Federal Aviation Administration

SAFETY ALERT

Subject: Corrected Sketch for Greater Cumberland Rgnl (CBE), Cumberland, MD

Correct depiction – digital-Terminal Procedures Publication (d-TPP)/ U.S. Terminal Procedures Publication (TPP) Vol NE-3

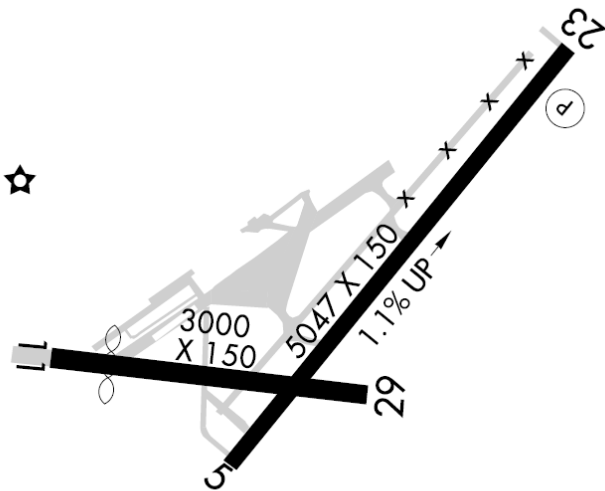
The airport sketch is depicted incorrectly at Greater Cumberland Rgnl (CBE), Cumberland, MD in the following publications:

The incorrect depiction shows RWY 05-23 located on a partially closed taxiway parallel to the runway's actual location. The affected Terminal Procedures are RNAV (GPS) RWY 05, ORIG and RNAV (GPS) RWY 23, ORIG. Correct sketch depictions are attached.

The corrected sketch will be published on October 29, 2026.
